Re: Officer South PSP – Stormwater Requirements for 105 Patterson Road, Officer

I have reviewed the macro stormwater requirements and concepts associated with the Officer South PSP and your clients land at 105 Patterson Road, Officer. The site is located at the southern edge of the PSP and is subject to a number of proposed drainage related assets. The site context from the PSP documentation is shown in Figure 1. This high-level review is based on this document and the following:

Figure 2. Proposed Water Assets Officer South PSP

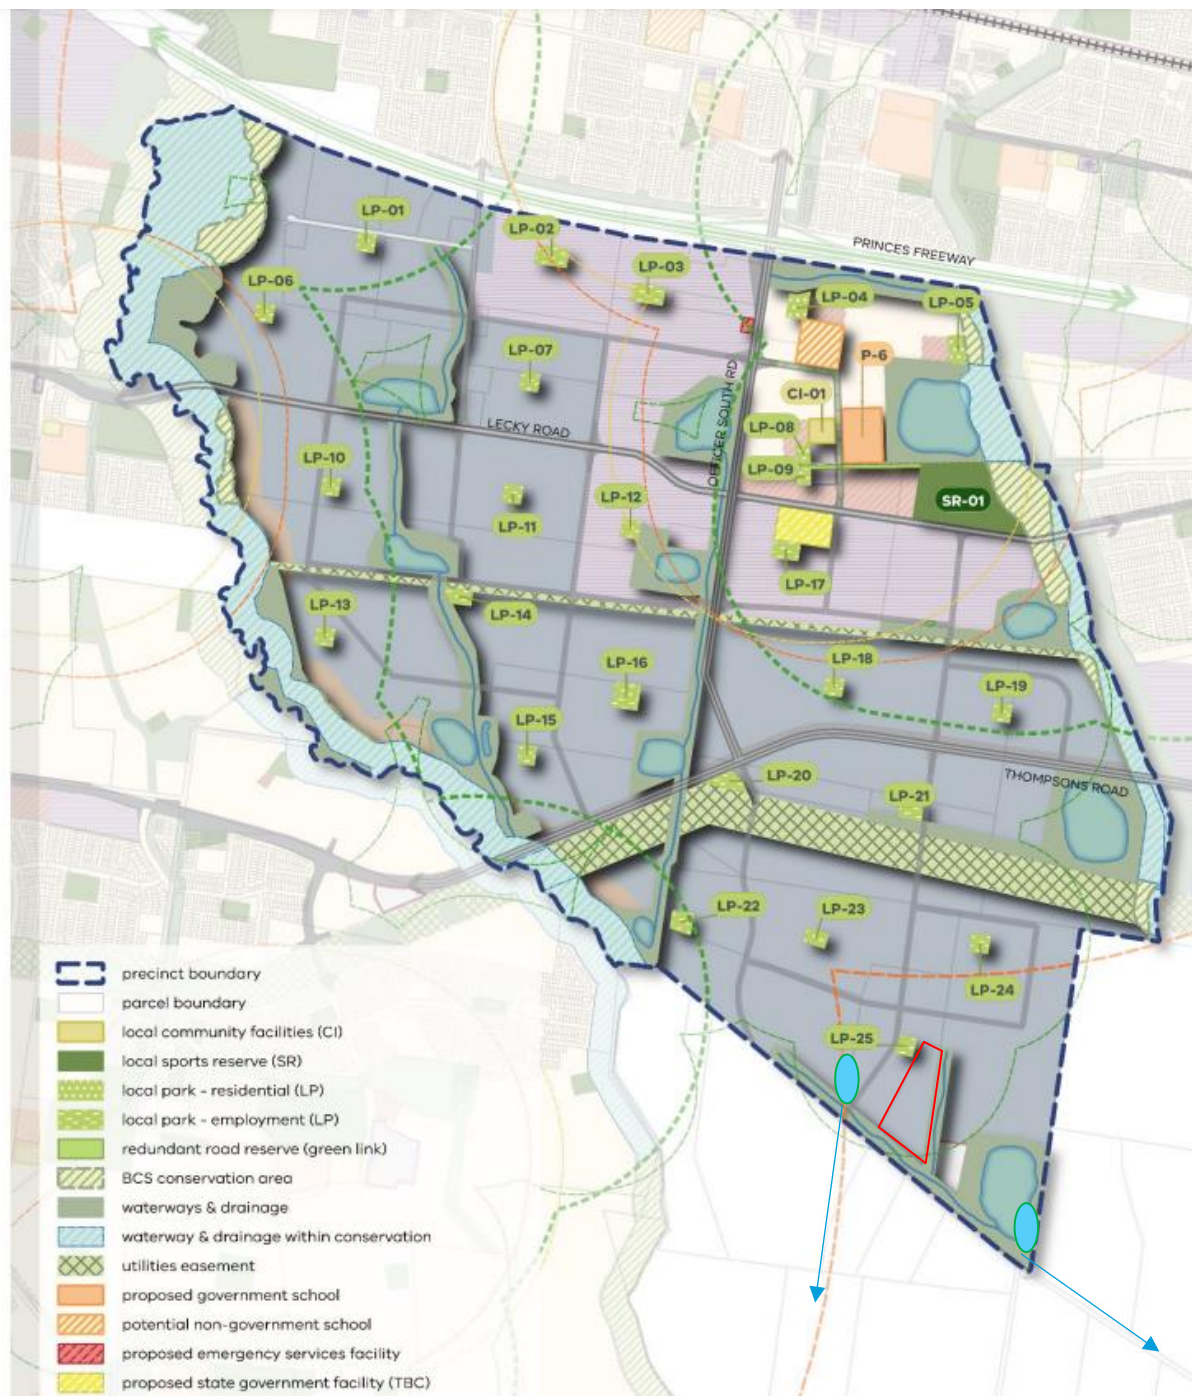
As shown in Figure 2, the PSP proposes a Waterway along the southern boundary of the property. It is also noted that a major wetland system is proposed to the east of the site, and a major sewerage pumping station is located within the vicinity. From this, and the proposed PSP boundary, it is theorised that all of these assets are located in these areas as they are required at the lowest elevation in the PSP. In some respects, the site and the surrounding land uses, and proposed water assets are dominated by this low elevation and have little to do with the best uses of the land in this part of the PSP. That aside the following points are noted for the water assets:

- The proposed location of the waterway along the southern boundary is not a current waterway location, and as such, this corridor should be purchased as part of the scheme.

- It seems the waterway is placed here due to the outfall invert restriction and the arbitrary edge of PSP. Were options outside of the PSP canvassed that could provide a better overall outcome? These might include:

- Wetland placement along Gum Scrub Creek corridor or connection point with Cardinia Creek.
 - Waterway to be placed on the current valley line (as is current MW policy) at 30 Patterson Road

- Could the waterways be aligned in a more north-south alignment to match the topography and existing drainage format. This would facilitate 2 smaller wetlands at ~30 Patterson Road as depicted in Figure 2. This would be a smaller capital cost (at the acknowledged higher operational cost for 2 wetlands/RBs)

- It is noted that large sewer mains would presumably be required in this waterway corridor (to connect to the pumping station) and as such the land take for this asset may be larger than as shown.

Based on this review, I suggest the following points are requested of the VPA consultation:

- Confirmation that if the waterway asset is placed on this parcel that the land will be reimbursed at the applicable development land use rate. This would be in line with current principles for development schemes and given that there are other hydrological options this would be a minimum requirement.
- Review if a single RB/wetland asset in this location (SE corner of the PSP) with associated waterways to facilitate the asset is the best arrangement of stormwater assets.
- Confirmation of the land take associated with the waterway corridor including the sewer asset offsets as required by Melbourne Water.
